Adhunik Poshak Shilpa Ltd.

Avenue-1, Industrial plot-1, Block-E, Section-11, Mirpur, Dhaka.

25 June 2014

Observations

High storage loads on level 5 and 3

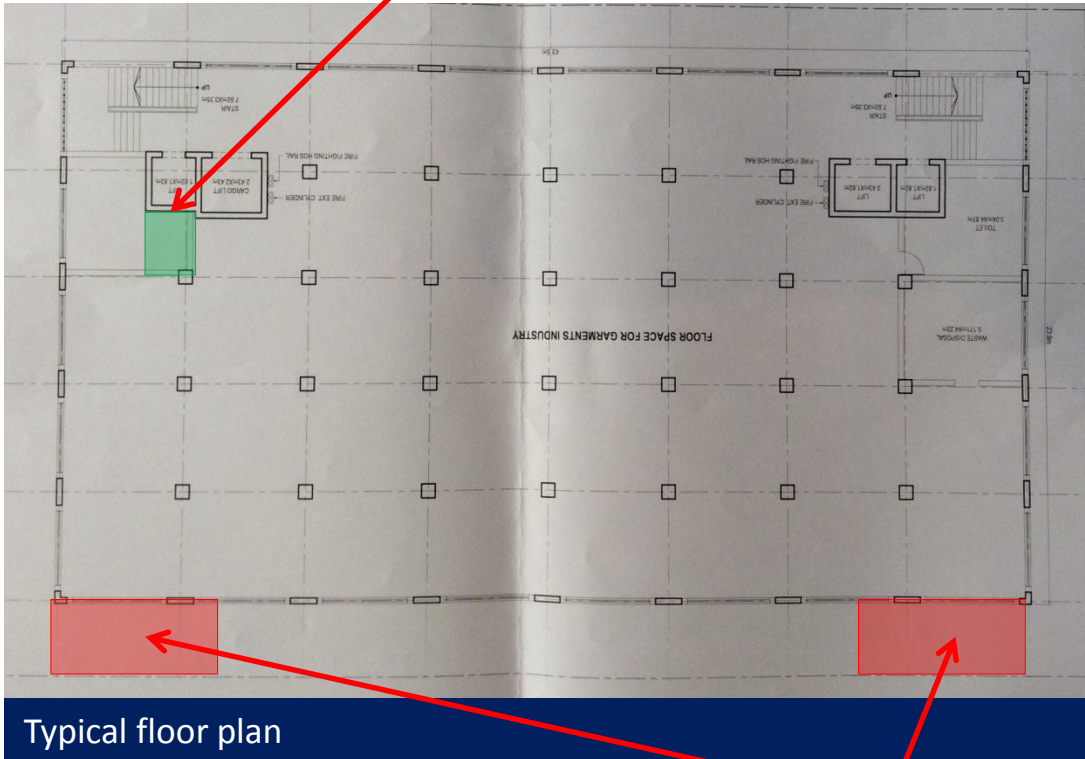
Areas of high loading observed

Heavy storage observed on several floors. Punching shear of the flat slab is a concern

Rolls of fabric stored on production/sewing floors
